NO. SI 20-089

BRP-Rotax GmbH & Co KG Service Bulletin SB-912-078

Exchange of propeller shaft on ROTAX® Engine type 912 / 914 (Series) and 912 i (Series)

Fig. 1

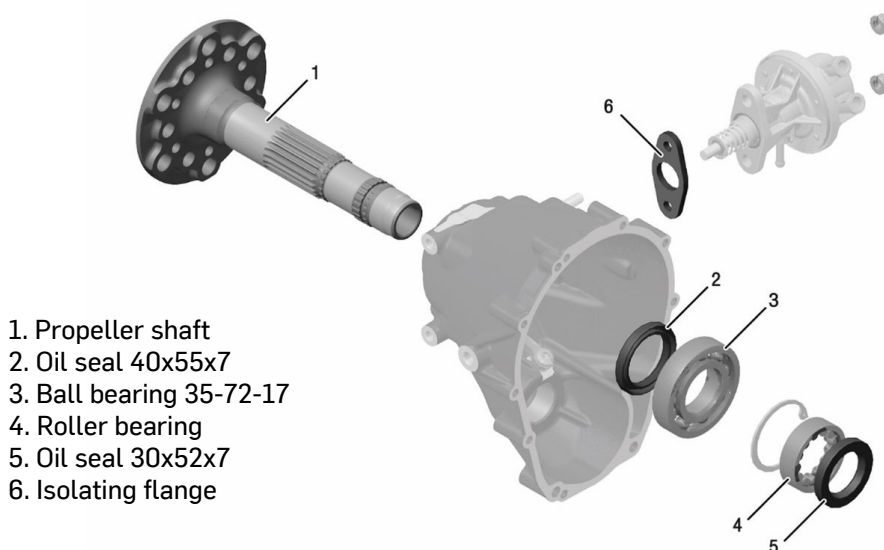
See Fig. 1.

Parts requirement in case of replacement:

Part no.	Qty/engine	Description	Application
937047	1	Propeller shaft	Version 2
832587	1	Ball bearing 35-72-17	Gearbox side
950470	1	Oil seal 40x55x7	Gearbox side
232246	1	Roller bearing	Crankcase side
950200	1	Oil seal 30x52x7	Crankcase side
950228	1	Isolating flange	Fuel pump (912 Series)
